# Coffs Harbour Development Control Plan 2015 – Amendment No. 38 (Laneways)

## Coffs Harbour Development Control Plan

**Rear Lane Setback Requirements**

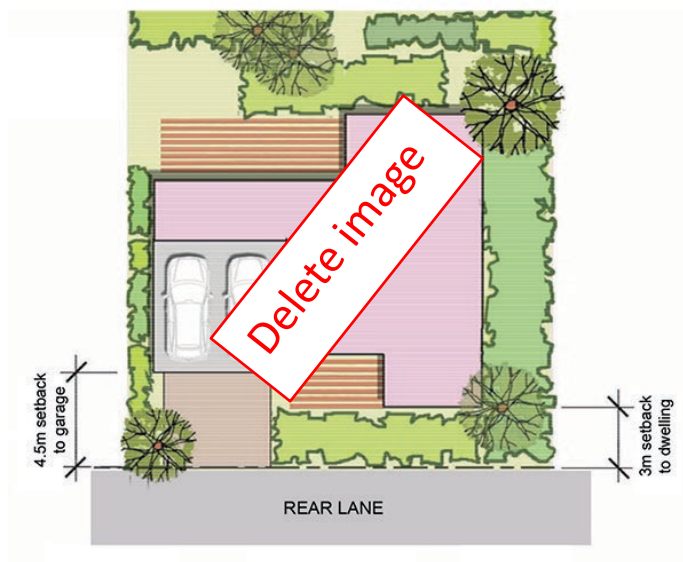
Amend bullet point 5 to ensure development activates laneways. Remove the associated image. The new exception should read as follows:

- ~~• Dwellings fronting a lane are to be setback three metres with garages and carports being setback 4.5 metres.~~
- Setbacks to development fronting a laneway are to be assessed on merit, and must align with regard to the objectives of this control.

## Rear Lane Setback Requirements

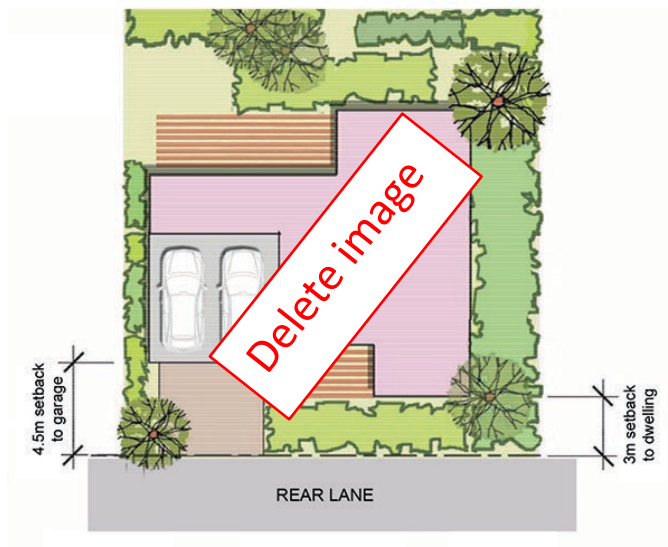
Amend bullet point 6 to ensure development activates laneways. Remove the associated image. The new exception should read as follows:

- ~~• Buildings fronting a lane are to be setback three metres with garages and carports being setback 4.5 metres.~~
- Setbacks to development fronting a laneway are to be assessed on merit, and must align with regard to the objectives of this control.
